SUBJECT: PALO VERDE NUCLEAR GENERATING STATION, UNIT 3 - SUMMARY OF
CONFERENCE CALL REGARDING 2006 STEAM GENERATOR TUBE
INSPECTION RESULTS (TAC NO. MD1240)

SUMMARY OF CONFERENCE CALL
REGARDING 2006 STEAM GENERATOR TUBE INSPECTION RESULTS
PALO VERDE NUCLEAR GENERATING STATION, UNIT 3
DOCKET NO. 50-530

Steam Generator Tube Inspection Discussion Points – Briefing Paper

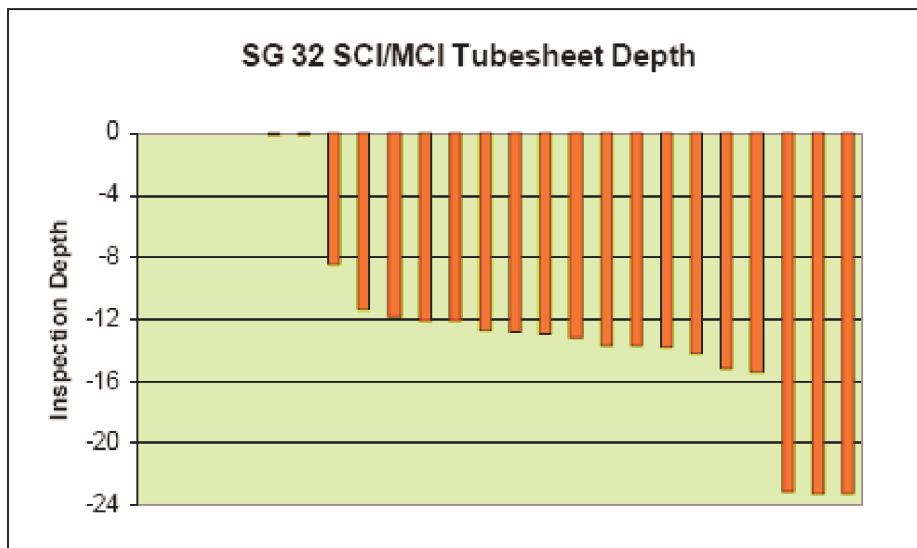
7. **Discuss the previous history of SG tube inspection results, including any “look backs” performed. Specifically for significant indications or indications where look backs are used in support of disposition (e.g., degradation mode or location of degradation new to this unit).**

Historical “look backs” to be discussed during briefing and in discussion of Item 8 regarding expansions.

With regard to tubesheet inspections, which was the focus of a call between APS and the NRC on March 29, 2006 and RAs with respect to C* criteria – The following update is provided.

As indicated in the 3/29/06 call, additional analysis performed by Westinghouse to accommodate “first slip” resulted in a change to the minimum inspection depth to 12.6 inches below the Bottom of the Expansion Transition (BET). APS indicated an intention to change the minimum inspection depth to 13 inches. For U3R12, the inspection was conducted at a 14 inch depth to provide additional margin. As such, the acquisition and data management personnel verify that at least 14 inches of inspection length below the

BET is acquired. As a figure of merit, the average inspection depth (from TTS) is 15.31 inches in SG 31 and 15.41 inches in SG 32.

As reported previously, in general, tubesheet SCC is not a progressing damage mechanism. That is, most of the defects detected are outside previously inspected elevations. Additionally, in the case of SG 31, no circumferential SCC was found outside the tubesheet transition region. For SG 32, the distribution of circumferential SCC indicates that most of the detected flaws are beyond the inspection depth performed in U3R11 (i.e., 12 inches). See below.
